**RE: Red Dog Mine Reclamation Closure Amendment Request for the Tailings Storage Facility Final Beaching Height**

**RED DOG TAILINGS STORAGE FACILITY – TAILINGS MAIN DAM BEACH CONFIGURATION AT CLOSURE**

**Project:**  
 RED DOG MINE  
 RECLAMATION AND CLOSURE PLAN

**Drawing Title:**  
 MAIN DAM BEACH  
 TYPICAL SECTION

## Main Dam Beach, Typical Section

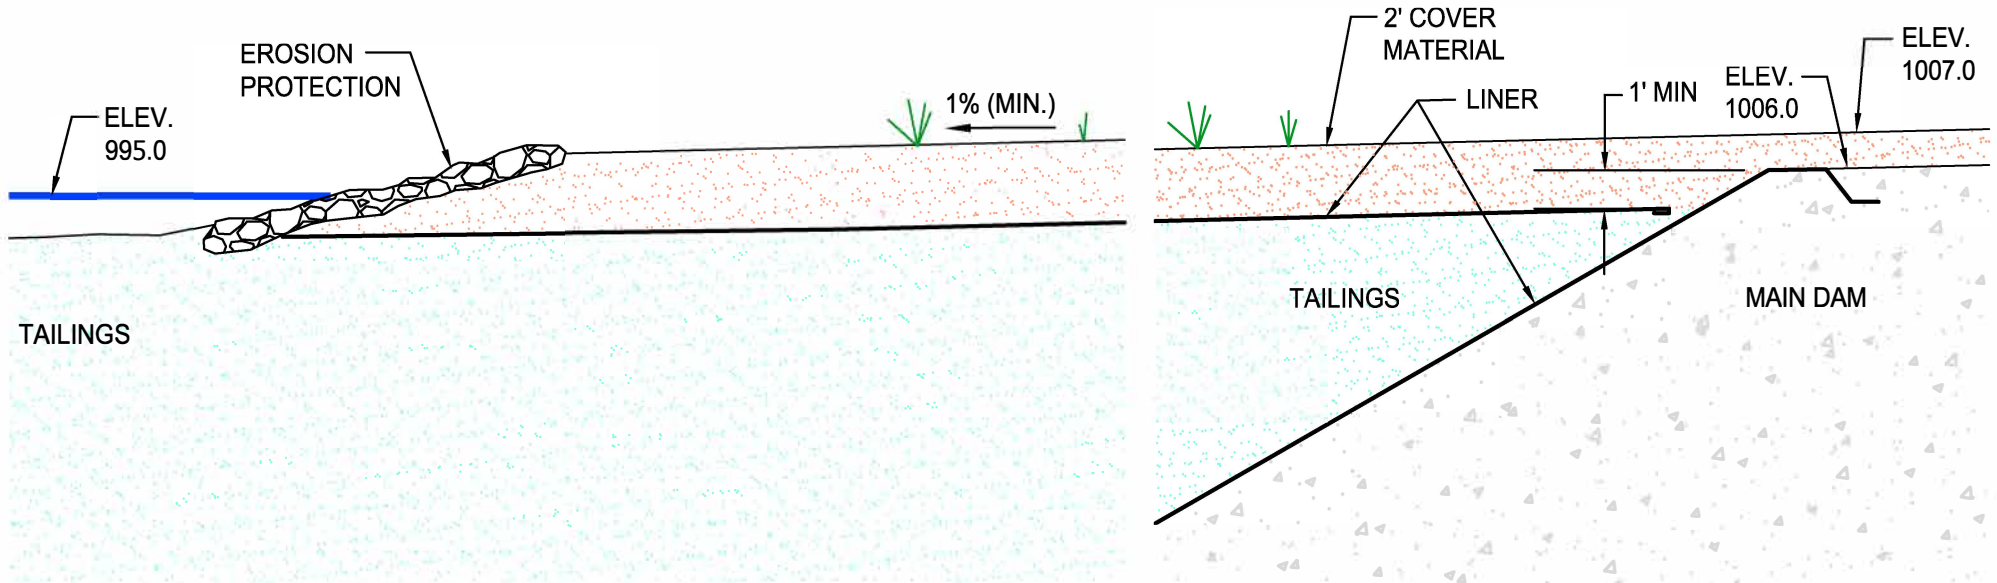
The current RCP assumes a struck tailings height of 975-ft. Teck is requesting to raise the struck tailings to a proposed nominal height of 993-ft for effective tailings deposition to ensure an adequate beach length and slope angle for the Tailings Main Dam (TMD) beach. Maintaining a target 600-ft beach width at the TMD has shown a significant reduction in seepage volume and is a dam safety best practice for the TMD. Changes to the beach closure configuration allow for the geometry required to create and maintain a 600-ft beach with both operational and closure TSF water levels.

Teck also requests to amend the closure cover material (unmineralized shale) requirement for the TMD beach area. Currently, the RCP requires a total cover material thickness of 40-in utilizing two separate 20-in layers – a compacted lower layer and uncompacted “vegetation” layer. Teck requests to remove the requirement for a 20-in compacted layer (RCP fig. 22) for the TMD beach area and proposes an uncompacted cover material thickness of 24-in placed above the synthetic liner over the TMD beach area (fig. 27, Golder report). The synthetic liner placed beneath the cover material provides a barrier to reduce oxygen from reaching the underlying tailings making the 20-in compacted layer in the original design unnecessary. The reduction of cover material thickness from 40-in to 24-in is requested only for the TMD beach areas.

To allow for the required 2-ft of cover material for vegetative growth and protection of the geomembrane from equipment traffic, a 1-ft cap of material will be placed on the crest of the TMD. Tailings would remain a minimum of 1-ft below the TMD's nominal seal zone.

The proposed closure section provided by Teck for Golder’s review is shown in Attachment 1, and allows for a maximum struck tailings elevation at closure of 993 feet, and a minimum normal pond elevation of 995 feet to maintain 2 feet of water cover over the tailings. Table 1 presents the elevations resulting from a hydrologic/hydraulic assessment carried out by Golder<sup>1</sup>. The assessment provides the derivation for the maximum struck tailings elevation, which match those shown in Attachment 1.

As shown in Attachment 1, the closure configuration allows for 2 feet of cover material placed over the 600-foot-wide beach, with a geomembrane liner separating the cover material from the tailings. One foot of beach freeboard is provided at the embankment, resulting in one foot of cover material overlying the upstream embankment crest. Although the slope of the erosion protection is not shown, Golder anticipates that if it is steeper than the tailings beach slope it would reduce the height of the wave runup.

Seepage modeling and operational experience have shown that a tailings beach established against the embankment significantly reduces seepage reporting to the underdrain system at the TMD. Teck has established in their closure plan a criterion that a 600-foot-wide beach be established against the TMD as shown in Attachment 1. Golder, as Engineer of Record (EOR) of the TMD, has reviewed this configuration, has assessed that it will not reduce embankment stability, and agrees with the concept, including maintaining the 600-foot-wide beach against the embankment.
